CARRIAGE HILLS PUD / POADP PLAN

Re: Carriage Hills

POADP # 673

REQUEST FOR REVIEW of POADP

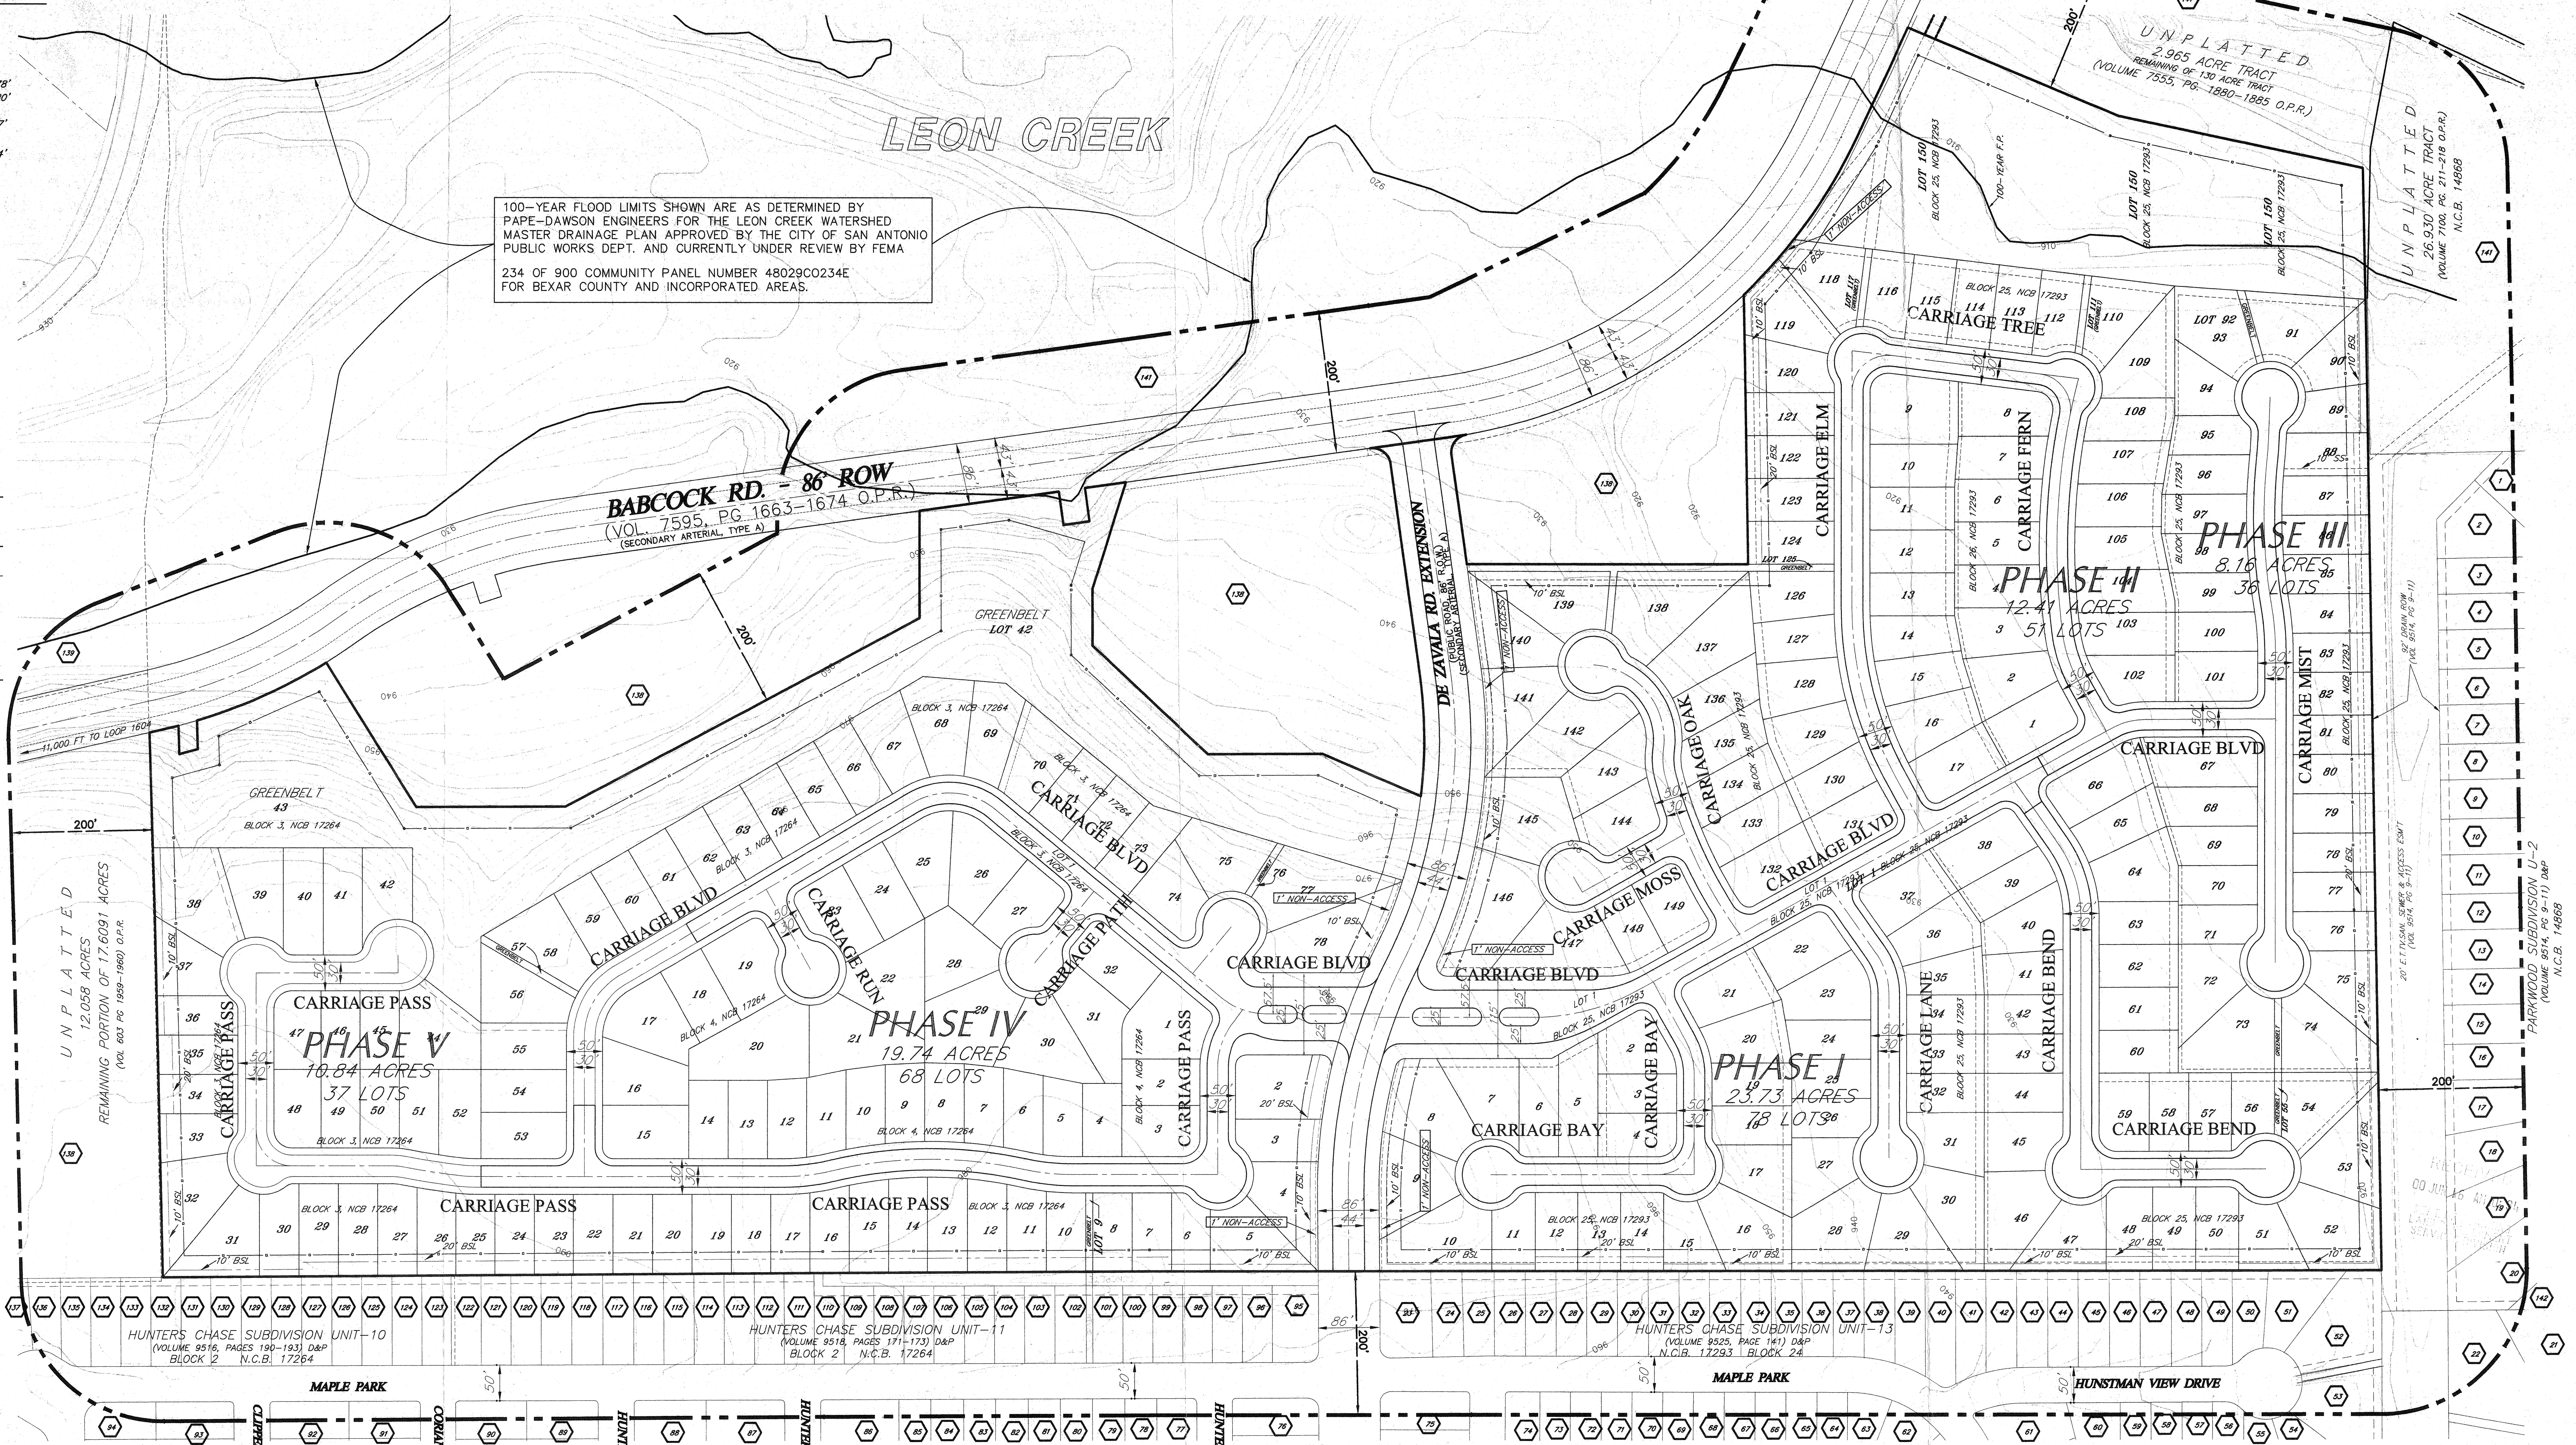
- Based on the topography, a Flood Plain Study and drainage review will probably be required during the platting process. Bexar County Public Works may require base flood elevations at the plat level.

- In consideration of public safety and convenience, excessive grades by reason of topography should be avoided in street layouts and arrangements.
- This development will probably need to conform to requirements associated with development over the Edwards Aquifer. For additional information about these requirements you can contact SAWS at 704-7305.

- Access and R.O.W. issues along State facilities will need to be resolved with the Texas Department of Transportation (TXDOT). For information about these requirements you can contact TXDOT at 615-5814.

- This development will need to comply with tree preservation ordinance #85262. For information about these requirements you can contact Building Inspections at 207-7102.

- It will be expected that you will plat all of the property depicted in your POADP, to include: floodpains, drainage areas and open space.
- I would encourage you to work closely with the school district, so that they can plan accordingly.

Comments: Dr. Zuzel's RP extension is
on the MTP requiring 2 min. of 86' ROW
